Arboricultural Consultation Response

Application No:	**Location:**
25/00787/HHFUL	Glatton Hall, Glatton Ways, Glatton
Case Officer: RK	**Proposals:** For the creation of a 12.5sqm shed, entrance gate posts, fencing and solar panels along the western roof of the western wing.

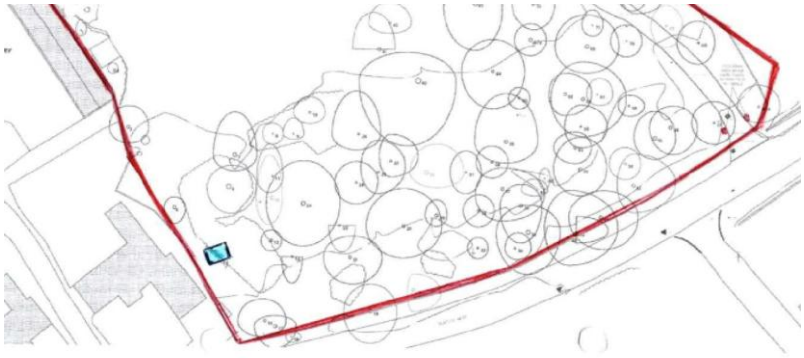
The gates to the front of the house are to be constructed on top of the original foundations, and should not impact the trees significantly as a result. However the photos of excavations show that there are significant roots in the vicinity. The locating of large stones would be adequate to prevent vehicular access and access/storage of materials within the Construction Exclusion Zone created, if located correctly. However, this isn't indicated on any of the mapping.

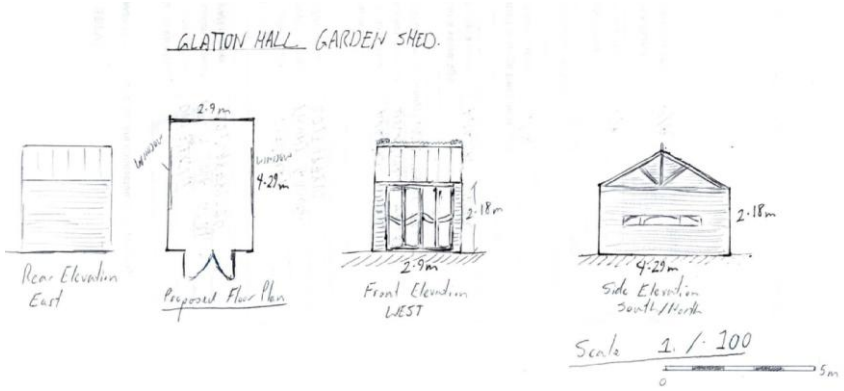
None of the photos provided show the shed or its location clearly, and the elevation plans do not provide any locational information or context.

The Method Statement indicates that NJUG Guidelines will be used, however BS5837:2012 or any replacement should be used. NJUG Guidance is for the installation of utilities such as broadband and powerlines, not domestic construction projects.
